Access Compliance Report

Public Rights-of-Way

Intersection ID: 47851	Main Street: CACTUS_VALLEY_RD	Cross Street: SERAPE_RD	Location: SE
ADA ID: 31C030307FB5	Ramp Type: Perp	Initial Pass/Fail: Fail	Overall Compliance: No
Severity Score: 8.75			
Codes/Mitigation Info/Possible Solution		Field Measurements/Component Compliance

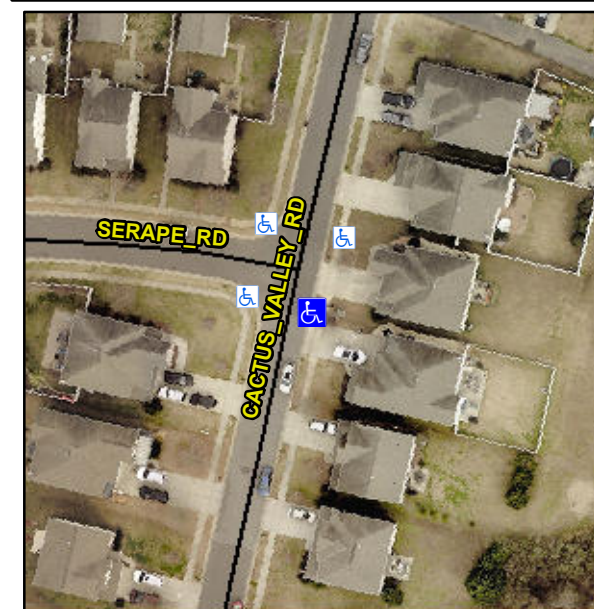
Not Found, R304.5.1

Compliance	Description	Data	Compliance	Description	Data
N/A	Ramp Length (in)	47.0	Yes	Ramp Slope (%)	6.0
No	Ramp Width (in)	47.0	Yes	Ramp XSlope (%)	1.0
N/A	Flare Type LT	N/A	N/A	Flare Type RT	N/A
N/A	Flare Slope LT (%)	N/A	N/A	Flare Slope RT (%)	N/A
N/A	Flare Traversable LT?	N/A	N/A	Flare Traversable RT?	N/A
N/A	Landing Length (in)	N/A	N/A	DWS Provided?	N/A
N/A	Landing Width (in)	N/A	N/A	DWS Contrast?	N/A
N/A	Landing Slope (%)	N/A	N/A	DWS Length (in)	N/A
N/A	Landing X Slope (%)	N/A	N/A	DWS Full Width?	N/A
N/A	Landing Curb? (Y/N)	N/A	N/A	DWS Offset (in)	N/A
N/A	Shared Landing?	N/A			
N/A	Gutter Ponding?	N/A	N/A	Gutter Slope (%)	N/A
N/A	Gutter Lip Ht (in)	N/A	N/A	Gutter X Slope (%)	N/A
N/A	Painted X Walk1?	No	N/A	Painted X Walk2?	N/A
	X Walk 1 Direction	To NW		X Walk 2 Direction	N/A
N/A	X Walk 1 Width (in)	N/A	N/A	X Walk 2 Width (in)	N/A
	X Walk 1 Slope (%)	1.4		X Walk 2 Slope (%)	N/A
	X Walk 1 X Slope (%)	0.8		X Walk 2 X Slope (%)	N/A

Remove & Replace Entire Ramp.
